APPLICATION NUMBER:		20/00861/F	VALID:	29/04/2020
APPLICANT: Beaufort He		omes Ltd	AGENT:	Ka Architectural Ltd
LOCATION:	LITTLE TH	IORNS LONDON R	OAD REDHILL	SURREY RH1 2JU
DESCRIPTION:	of a block landscapii 27/07/2020	Demolition of a detached house and gar of a block of 7 no. Apartments including landscaping. As amended on 05/06/2020 27/07/2020, 01/10/2020, 05/10/2020, 05/1 06/11/2020.		arking and 0/06/2020,

APPLICATION NUMBER:		20/00861/F	VALID:	29/04/2020
APPLICANT:	Beaufort Homes Ltd		AGENT:	Ka Architectural Ltd
LOCATION:	LITTLE THORNS LONDON RO		OAD REDHILL	SURREY RH1 2JU
DESCRIPTION:	Demolition of a detached house and garaging, and construction of a block of 8 no. Apartments including parking and landscaping. As amended on 05/06/2020, 30/06/2020, 27/07/2020, 01/10/2020 and on 05/10/2020.

This is a full planning application for a block of 8 no. apartments including parking and landscaping following the demolition of the existing detached dwelling.

Street Elevation/ Section Comparison with 2005 Scheme

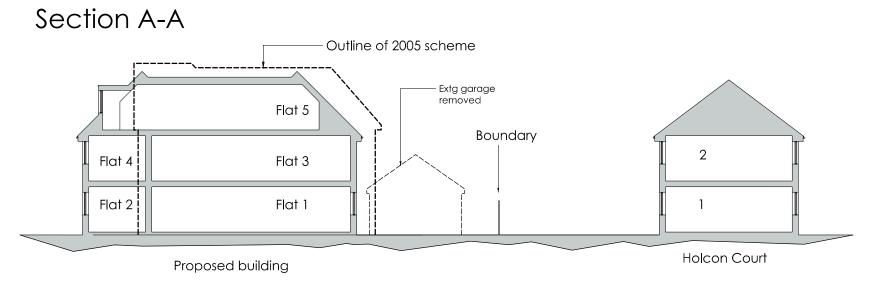
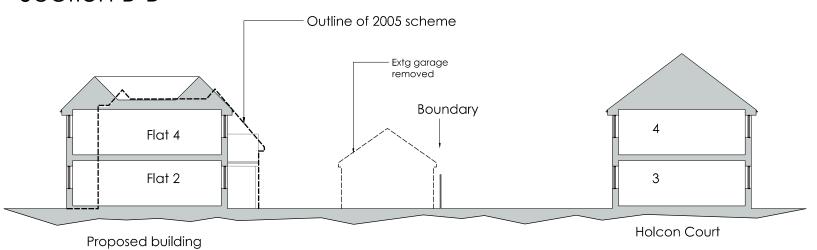
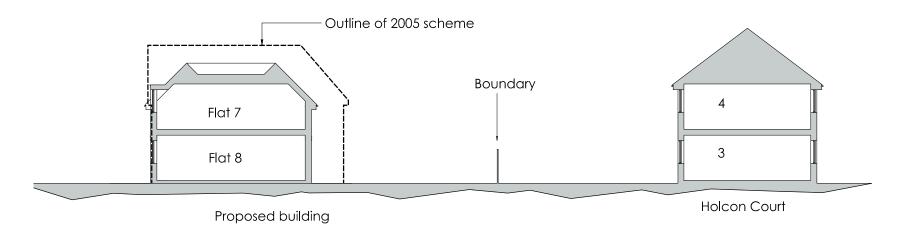
Drawing 2008/PL19 also includes the outline of the existing dwelling and 2005 scheme. The plan shows that the proposed scheme is not significantly higher than the existing dwelling and would be set further away from Holcon Court than the current dwelling and that the proposal is now further away from Holcon Court and in the case of two of the sections (A-A and C-C) lower than the 2005 scheme. Section B-B shows that the proposed building would now be similar in height to the 2005 scheme. The applicant has also provided two comparison plans, 2008/PL16A (South Elevation Profile comparison) and 2008/PL18A (Site Plan Comparison with 2005 Scheme), to help highlight the differences between the current scheme and the 2005 scheme.

A	3.11.20	Roof profile amended Section B-B
		B
